ARTICLE 14 RESPONSE

Churchtown Landfill Site

IBR1015
Article 14 Response
Final
16 July 2019

Drawing Number IBR1015/106	Rev -
--------------------------------------	----------

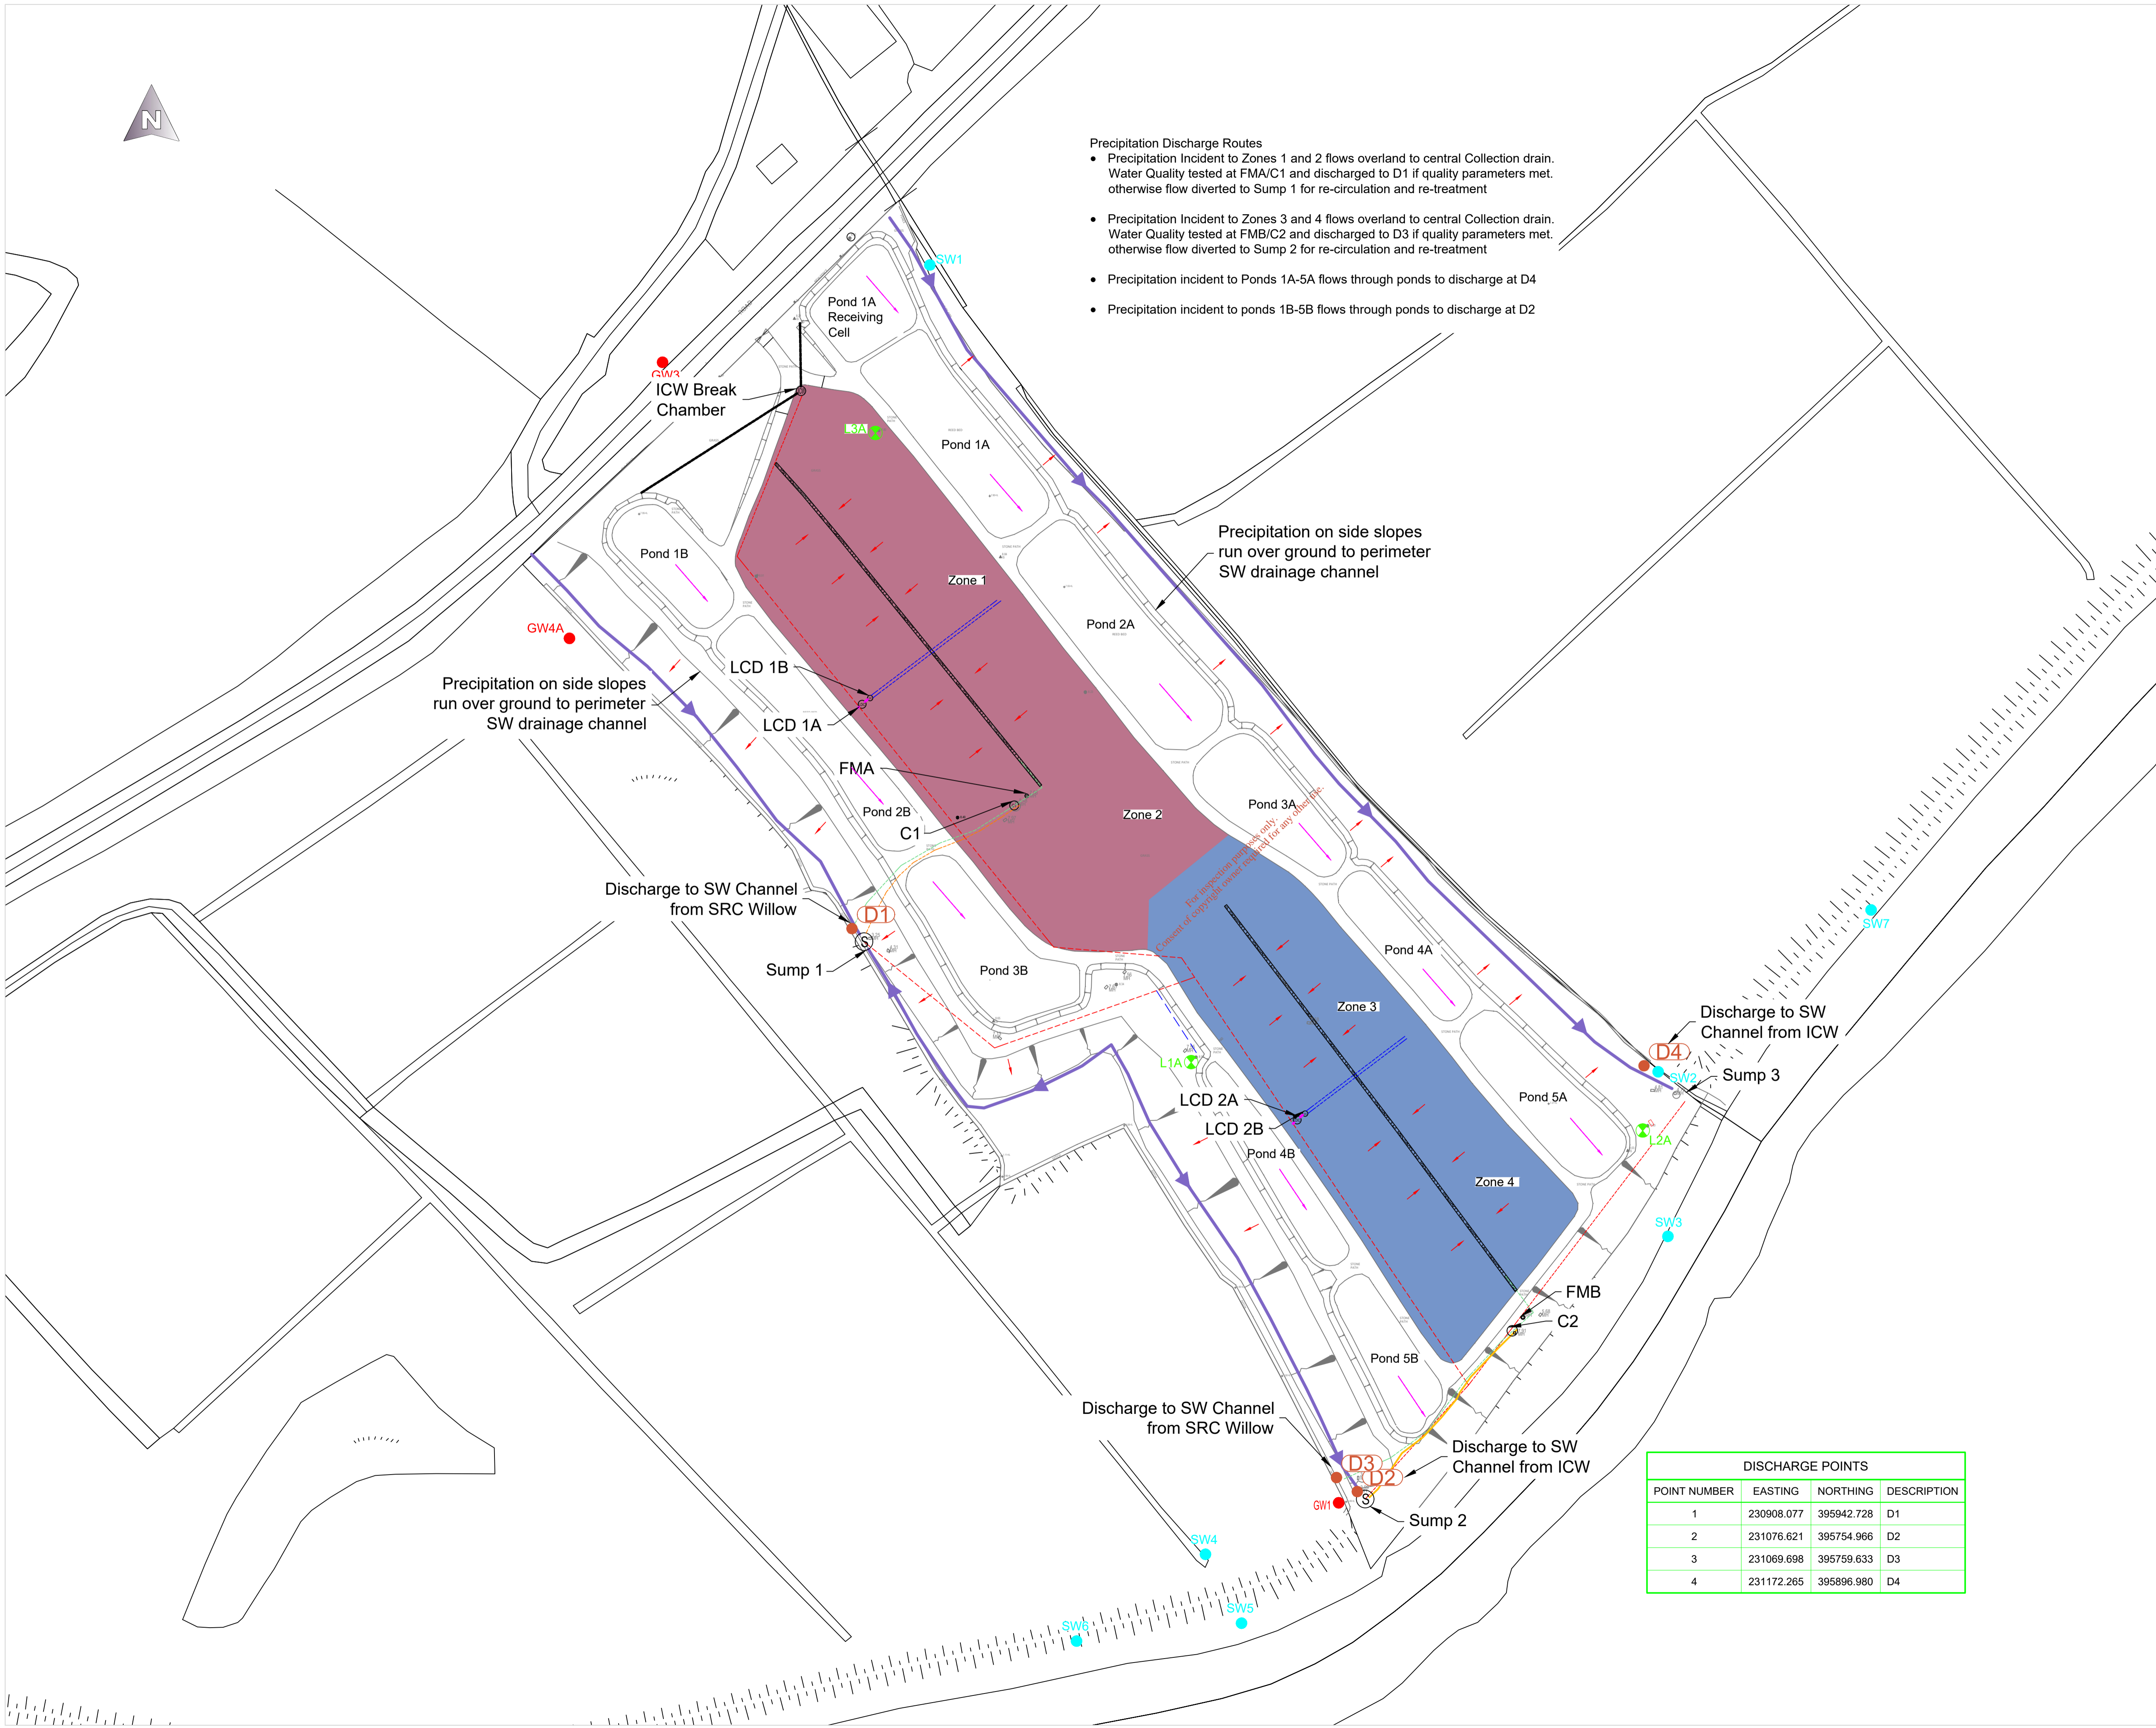
Explain how storm water arising from the site is managed. Include a drawing showing the storm water discharge locations.

All rainfall that fall on the slopes of the landfill is collected in the existing drains which run along the eastern and western boundaries of the site prior to discharge to the River Finn as shown on Drawing IBR1015/106.

- Precipitation Discharge Routes**
- Precipitation Incident to Zones 1 and 2 flows overland to central Collection drain. Water Quality tested at FMA/C1 and discharged to D1 if quality parameters met, otherwise flow diverted to Sump 1 for re-circulation and re-treatment
 - Precipitation Incident to Zones 3 and 4 flows overland to central Collection drain. Water Quality tested at FMB/C2 and discharged to D3 if quality parameters met, otherwise flow diverted to Sump 2 for re-circulation and re-treatment
 - Precipitation incident to Ponds 1A-5A flows through ponds to discharge at D4
 - Precipitation incident to ponds 1B-5B flows through ponds to discharge at D2
